**CITY OF FORT COLLINS**  
**TYPE 1 ADMINISTRATIVE HEARING**  
**FINDINGS AND DECISION**

PROJECT NAME: Brownes on Howes

CASE NUMBER: FDP140019

### STAFF REPORT

BROWNES ON HOWES  
**SITE PLAN**  
 FINAL DEVELOPMENT PLAN

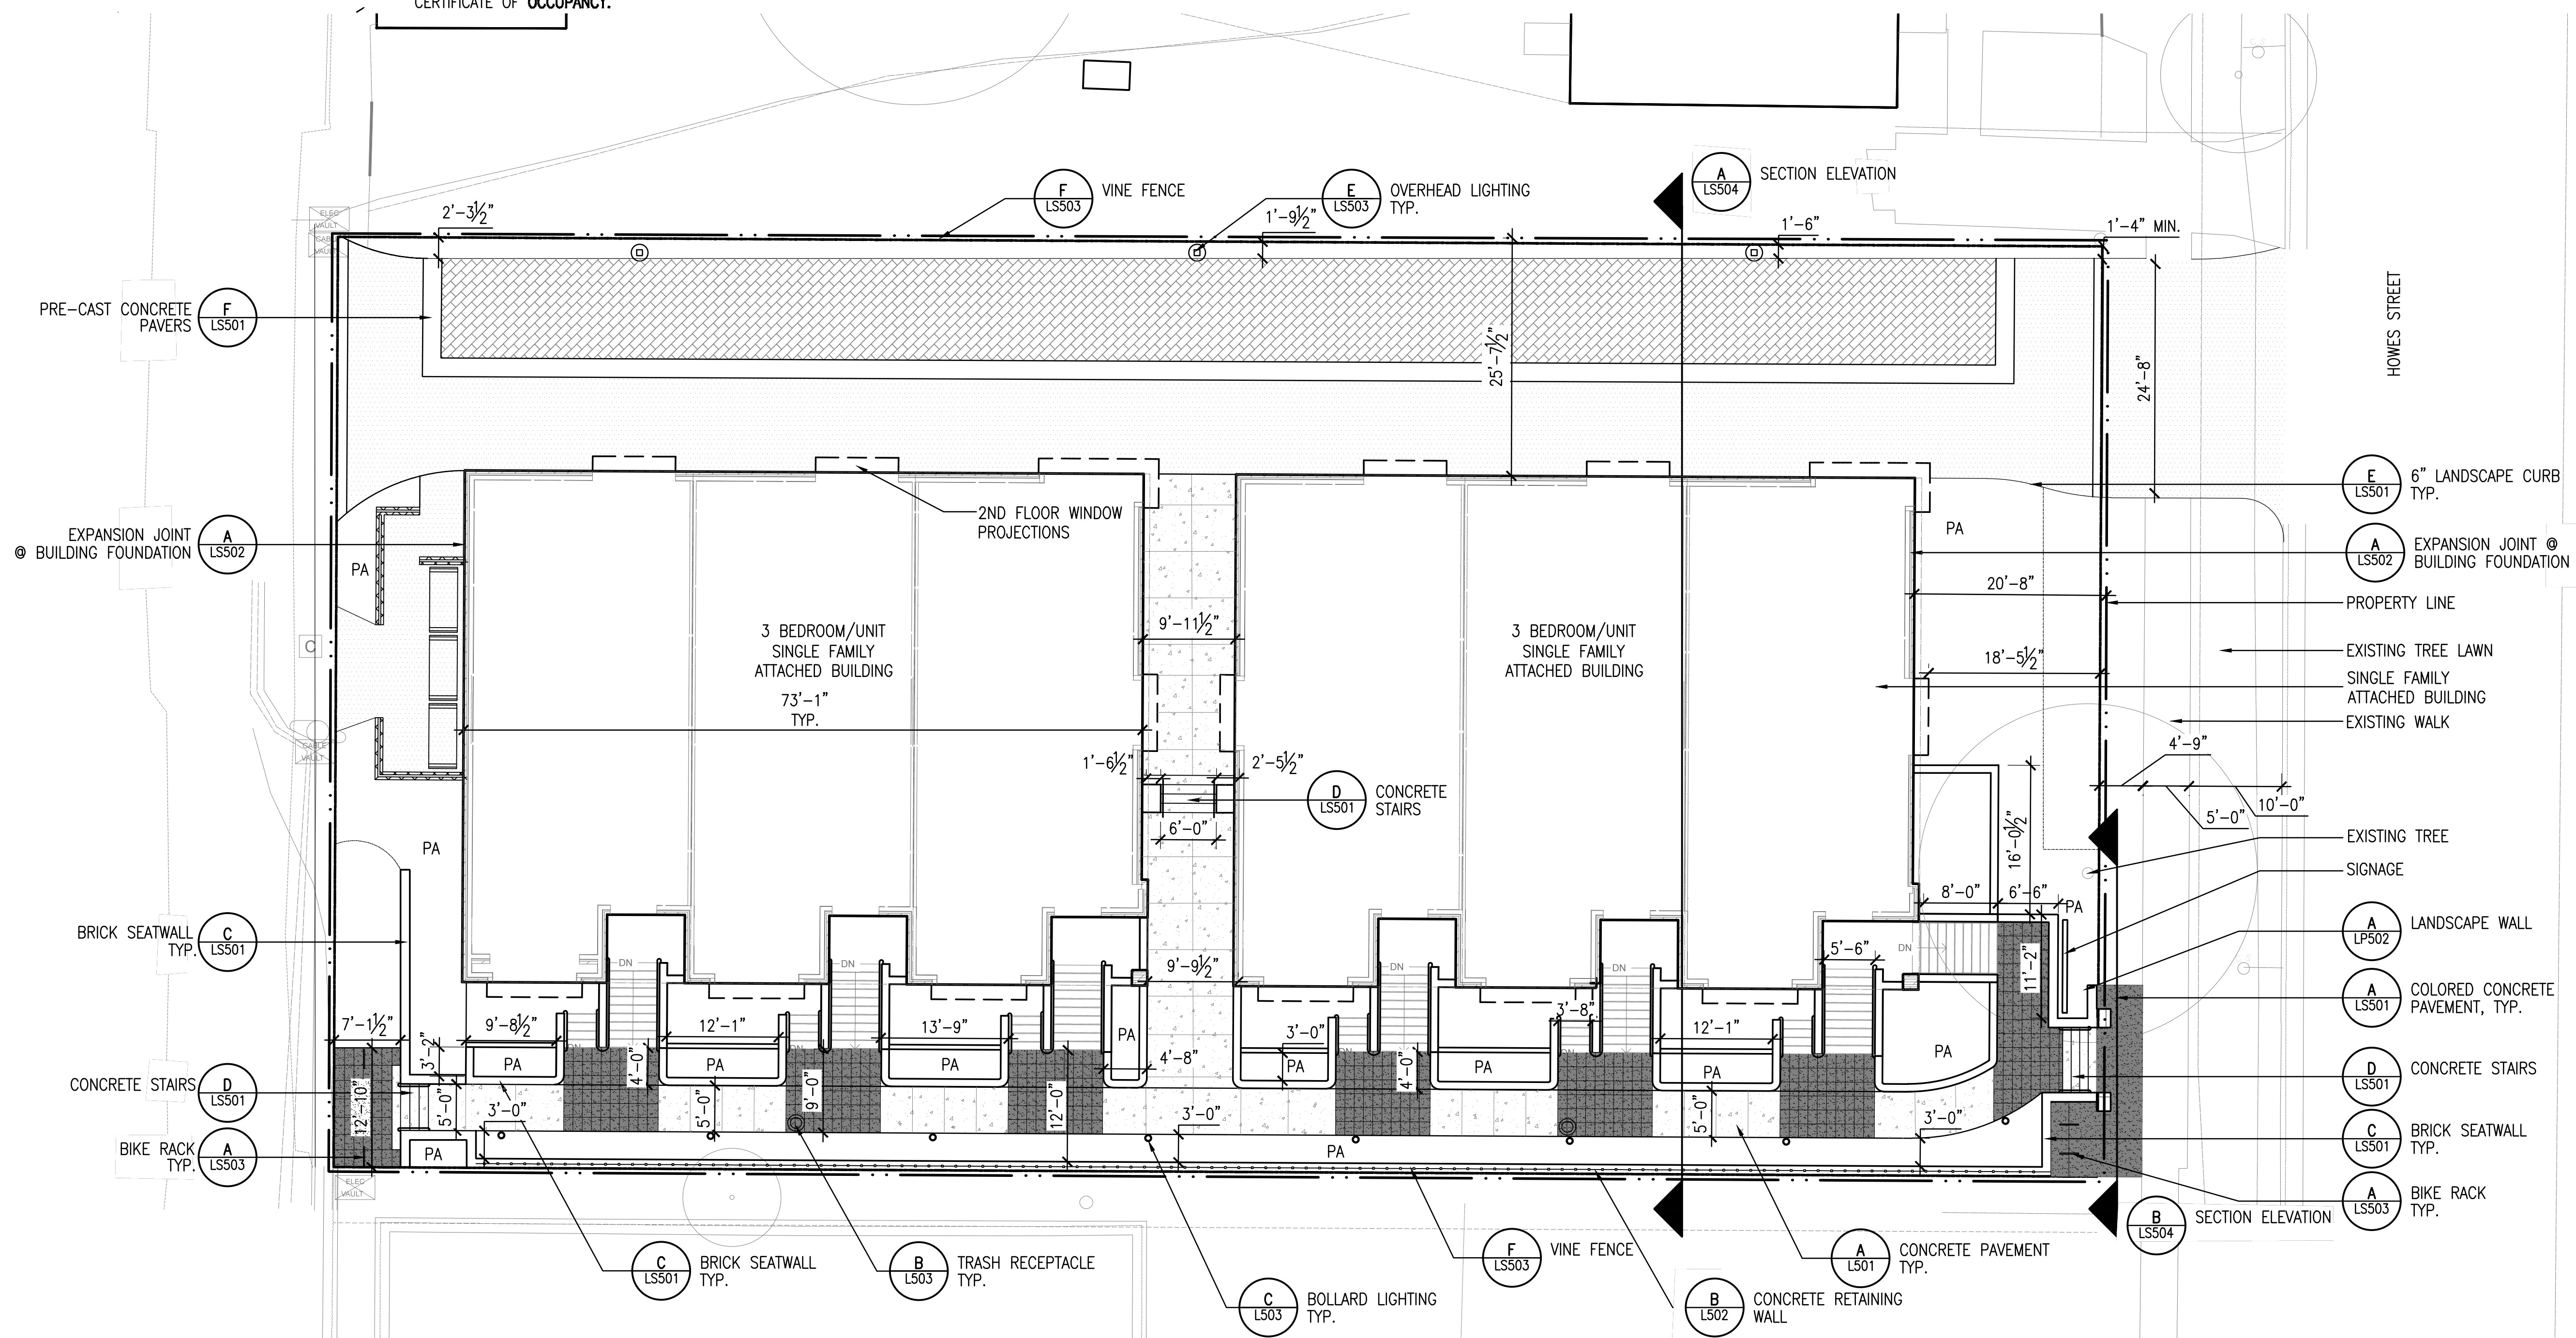
The proposed landscape setback along the north property line and the vehicular drive aisle is an area that tapers from 2'-4" to 1'-4".

- Staff finds that the request is not detrimental to the public good, and that the granting of the modification will not diverge from the standards of the Land Use Code except in a nominal and inconsequential way (4). The area is proposed to utilize small trees, shrubs, and a vine-covered fence to provide a screen between the drive aisle and the neighboring property. Additionally, the site layout that proposes the drive aisle along the north edge of the property creates greater separation between the buildings and the residential neighbor's property. In this site plan, the proposed buildings are 25 feet from the property line and 40 feet from the existing single-family house.

**Reduction of 5’ landscape area buffer from lot line to parking drive aisle from 5’ to a range between 2’4” and 1’4”**

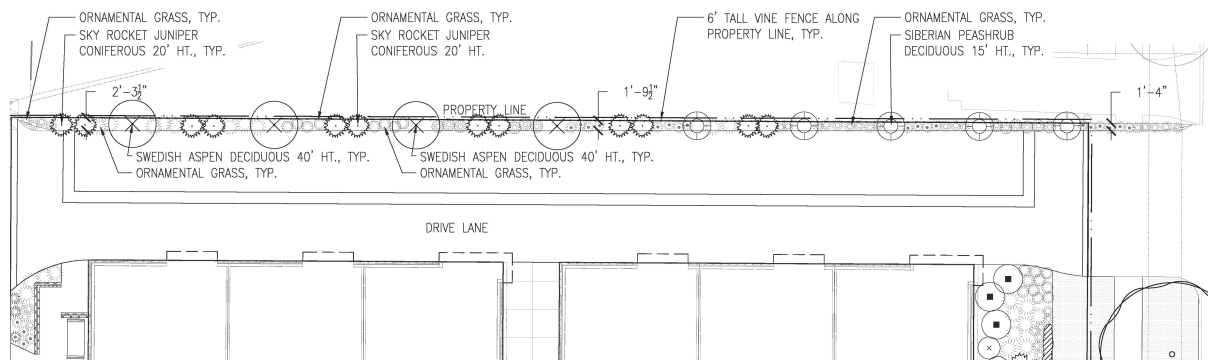
The applicant requests a modification from the setback standard of 5' of landscape area from the lot line to parking drive aisle exceeding 1,800 square feet, as outlined in 3.2.2(J). It is requested that this standard be modified on the North lot line to a setback varying from 2'4" to 1'4" to account for a 24' drive aisle from face of curb to building face/garage access points along the north side of the building. The lot line does not run parallel to the building and drive aisle, resulting in the variation from 2'4" to 1'4" of the landscaped area. This modification is requested for the North edge of lot 5 of the project under the following rationale:

1. The proposed plan is **nominal and inconsequential** in that regardless of the loss of a small amount of buffer distance with the proposed modification, a landscaped buffer is still established through the addition of a vine-covered fence, as well as small trees, shrubs and grasses in the buffer area, providing a sufficient landscape buffer and screen. The North edge of the lot borders a single-family residential property. The addition of the proposed vegetation provides a necessary buffer and transition to the adjacent lot.
